**Re: Draft Permit No. 1070014-001-AV
Heat Input Information for Oil Firing
FPL Putnam Plant Initial Title V Permit**

Re: Request for Additional Information Regarding Initial Title V Permit Application
File No. 1070014-001-AV
Putnam Plant, Putnam County

U.S. EPA Region 4 Objection
Proposed Part 70 Operating Permit
Florida Power & Light, Putnam Plant

Putnam Plant Unit 1 or 2
Heat Input Variation With Ambient Temperature (Oil)
Each Combustion Turbine (with / without duct burners)

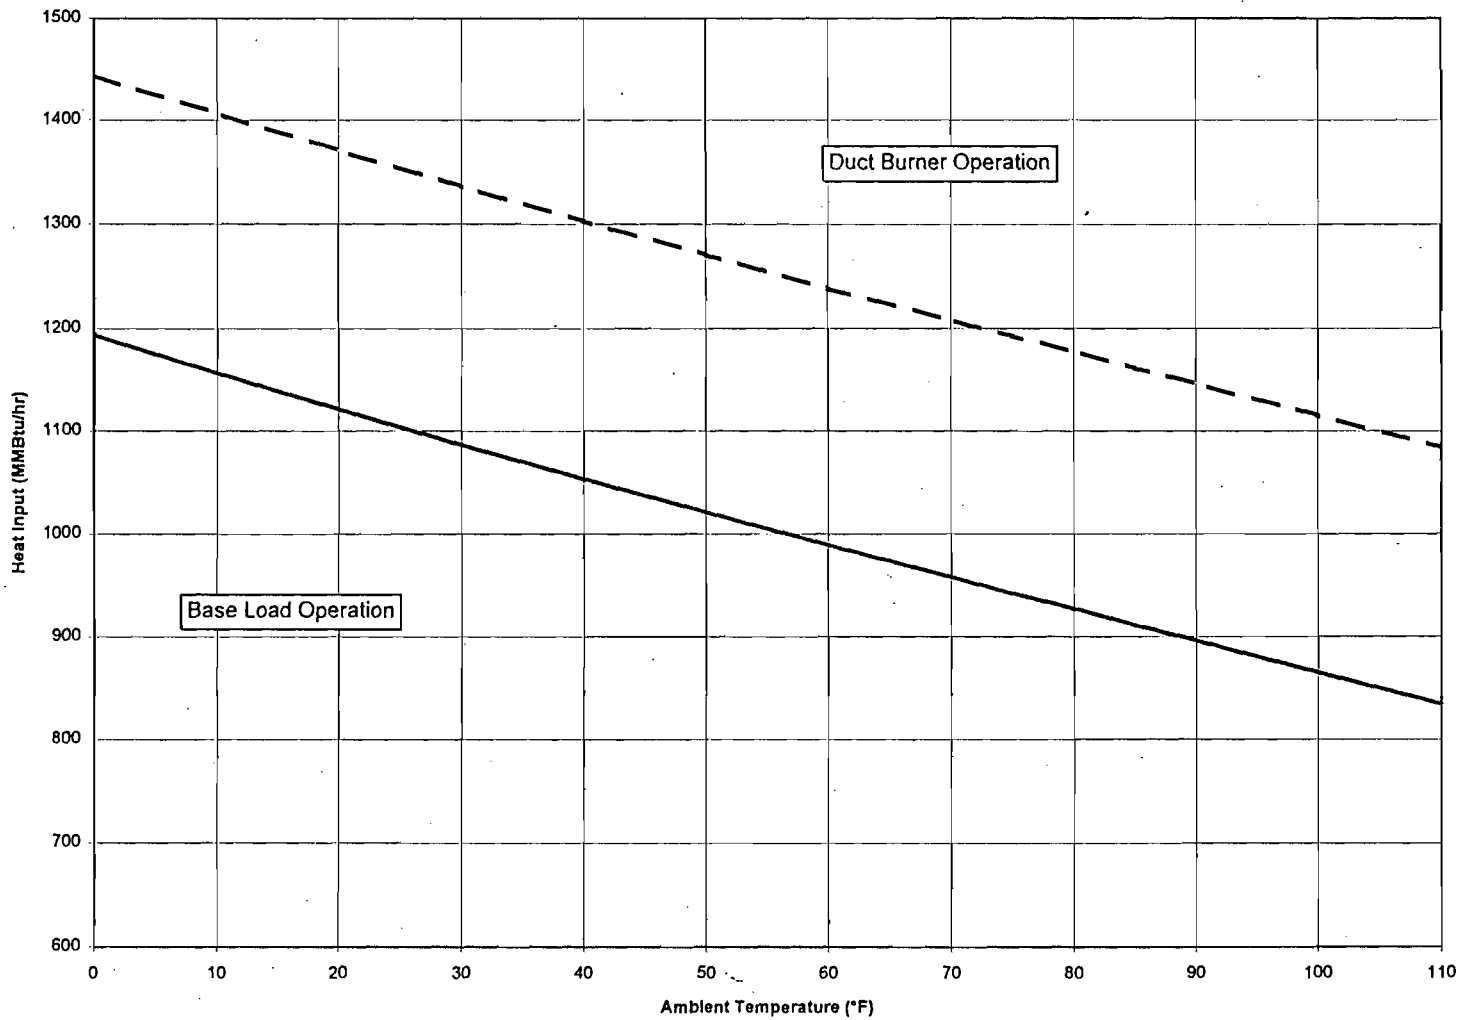
Attached for your use please find a graph of the ambient temperature vs. heat input data for the Putnam plant combustion turbine units for distillate oil firing.

Putnam Plant Unit 1 or 2
Heat Input Variation With Ambient Temperature
Each Combustion Turbine (with / without duct burners)

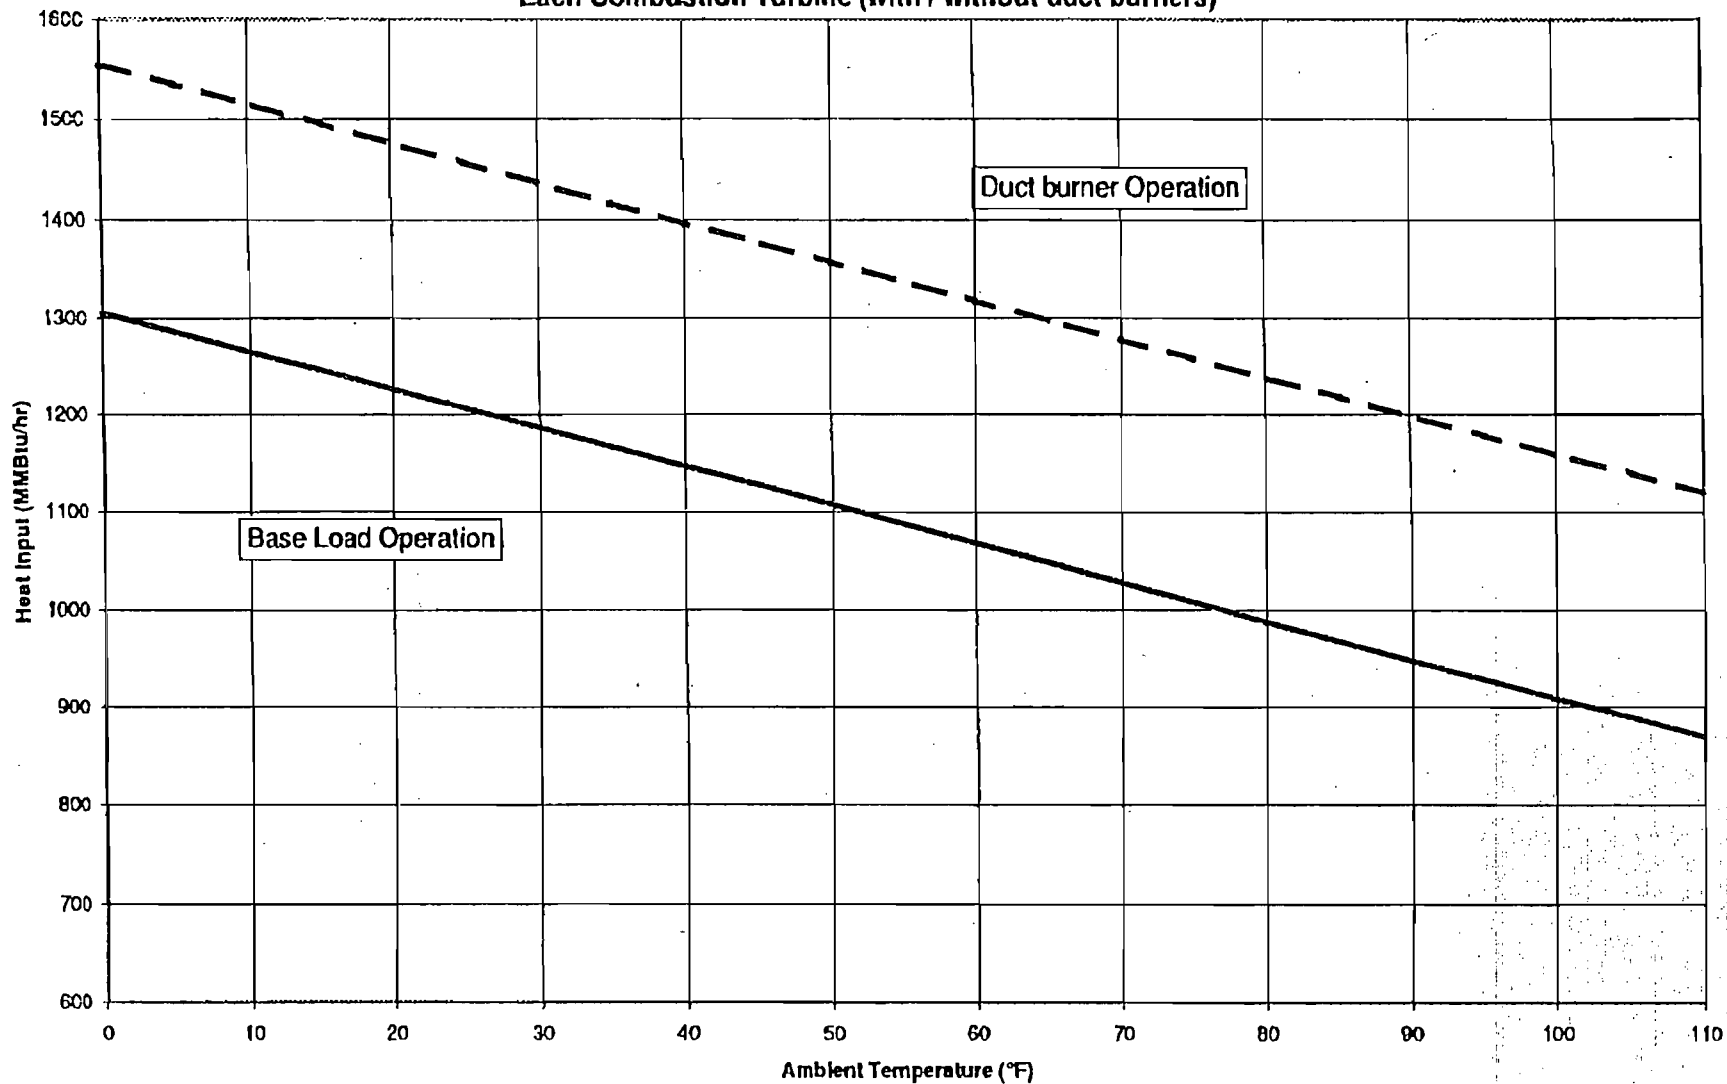
Enclosed for your use please find a copy of the heat input vs. ambient temperature graph for the subject facility.

**Putnam Plant Unit 1 or 2
Heat Input Variation With Ambient Temperature
Each Combustion Turbine (with / without duct burners)**

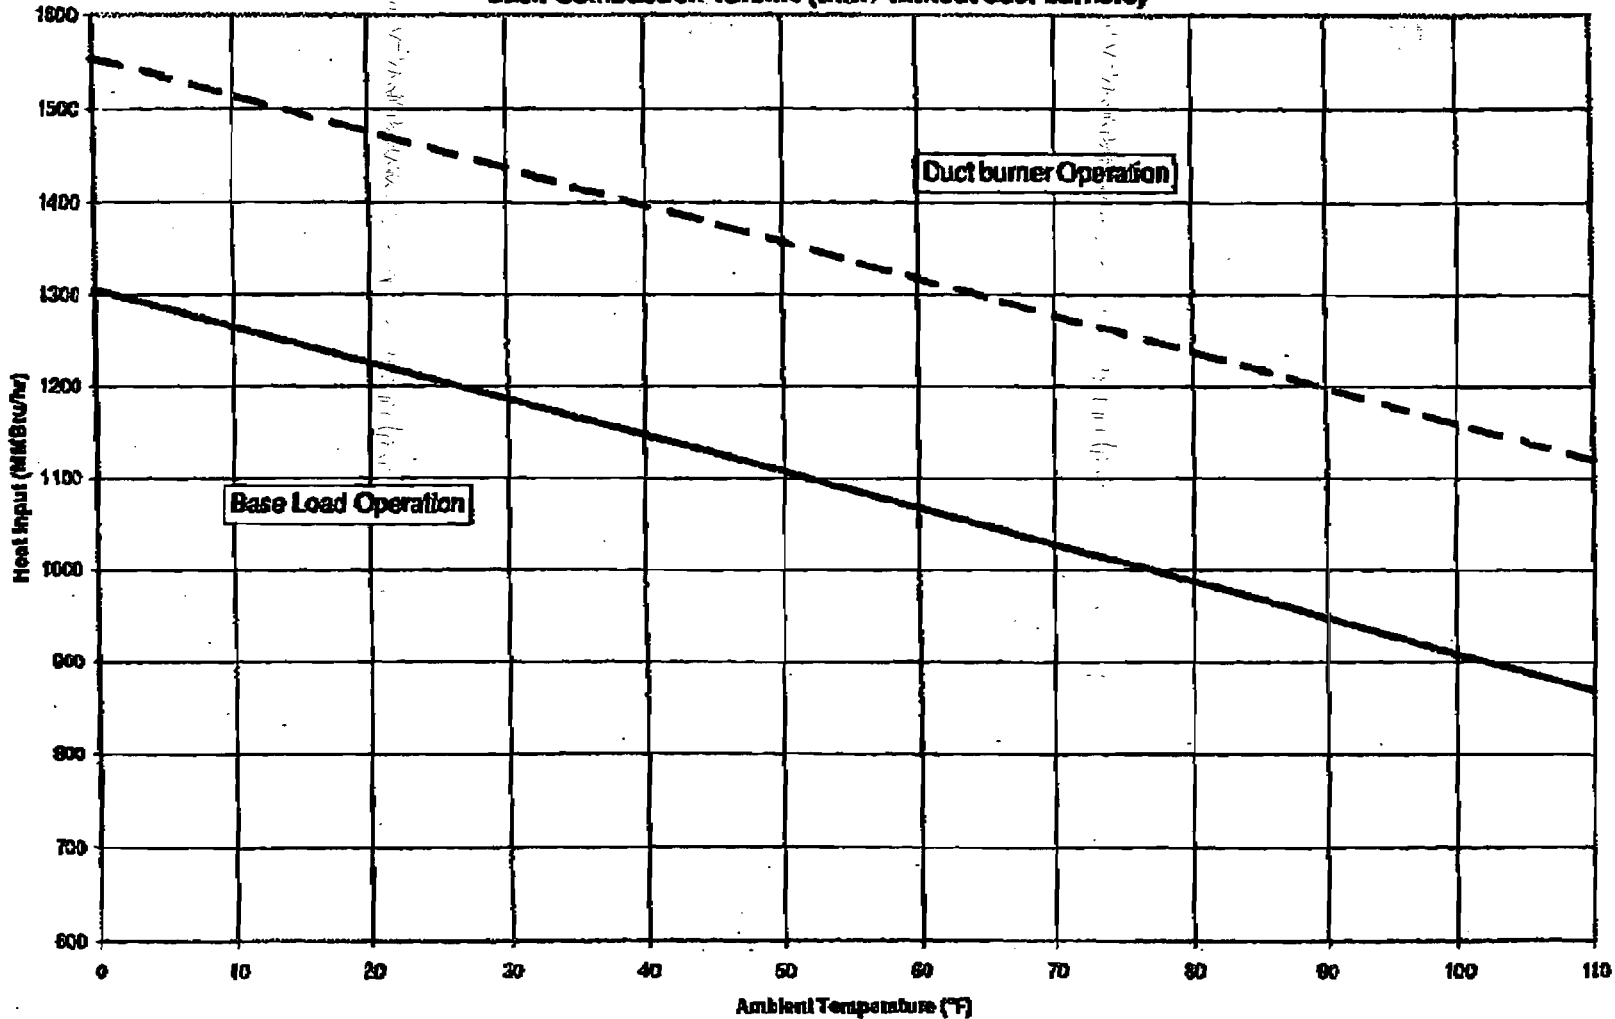
Putnam Plant heat input → the number to use as a
reference in the various places in the permit is 1265
mmBTU's at 10° F.
